Office Action Summary

10/751,565

UEDA ET AL.

FIG. 1

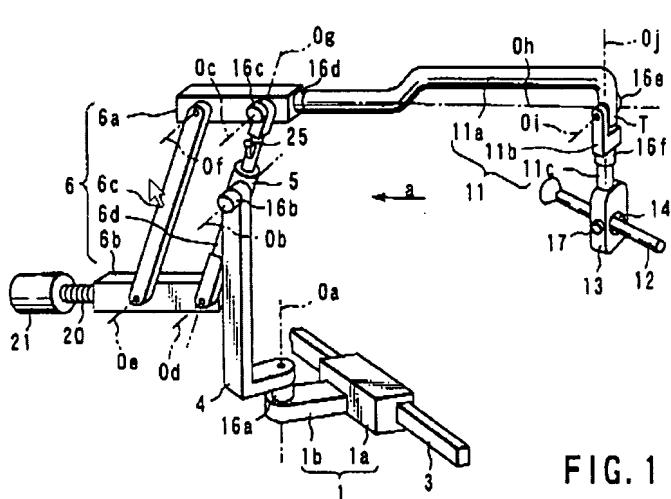
Applicant's arguments filed with respect to 35 U.S.C. § 102 and 103 have been fully considered but they are not persuasive. Shimmura et al. disclose that the support arm (Fig. 1, # 11a) can pivot or rotate about an axis-of-rotation Oh (paragraph 0057). Such rotation allows the support for the medical device to be positioned above, below or anywhere between these positions as the arm is rotated. The arm with the ball joint (Fig. 7) also disclosed the Oh axis. It is also noted for the record that the position of the ball joint with respect to the instrument is not disclosed as being critical or providing any unexpected benefit.

U.S.C. 102(b) as being anticipated by U.S. Patent Application Publication US 2001/0027313 to Shimmura et al. Shimmura et al. teach a medical instrument holding apparatus with a portion for holding an instrument (Fig.

1, # 14), a support arm (Fig. 1, # 11a), a base support (basal portion, Fig. 1, #s 3 & 4), a shaft coupled to the basal support (Fig. 1, # 4), the shaft forming part of a parallelogram moving (moving mechanism) structure (Fig. 1, # 6) with a counterweight (Fig. 1, # 21) to offset the weight of the support arm (Fig. 1, # 11a) and instrument. Multiple axes of rotation within the supporting mechanism are disclosed (Fig. 1, #s 0a – 0j). Arm 6a is clearly shorter than arm 6c of the parallelogram. A ball joint is disclosed that connects the moving portion to an instrument support portion (Fig. 7, #16h). The support shaft (Fig. 1, # 11a) has an axis-of-rotation (0h), inherently allowing the ball joint to be above, below or on a horizontal plane with the instrument holding means. As the angle of inclination within the ball joint changes, so will the position of the center of gravity, said center of gravity also being dependent on the size and weight distribution of the instrument. Since the center of gravity of the instrument and support depends on the instrument and the orientation, the ball joint is clearly capable of being oriented in any relation to the center of gravity. An operator may grasp any portion of the support and instrument elements. Electromagnetic locks as means for braking their respective movable sections are disclosed (Fig. 1, #s 16a-16f), with an activating switch on the holding portion (paragraph 0059). A braking means is also disclosed for the ball joint (paragraph 0092). The instrument holding portion is interpreted is capable of being held by an operator and is coupled to the support arm by rotatable joints (Fig. 1, #s 16e & 16f). The upper portion of the parallelogram is shorter than the lower portion with the counterweight and either of the side arms. The counterweight is adjustable via screw threads (Fig. 1, # 20).

The apparatus of Shimmura et al. implicitly has centers of gravity, centers of inclination and forces exerted within the device based on the weights of the instrument and counterweights. Relative positions of apparatus components will vary as the instrument is

positioned and can assume limitless configurations. The apparatus is therefore interpreted as capable of the position(s) cited.
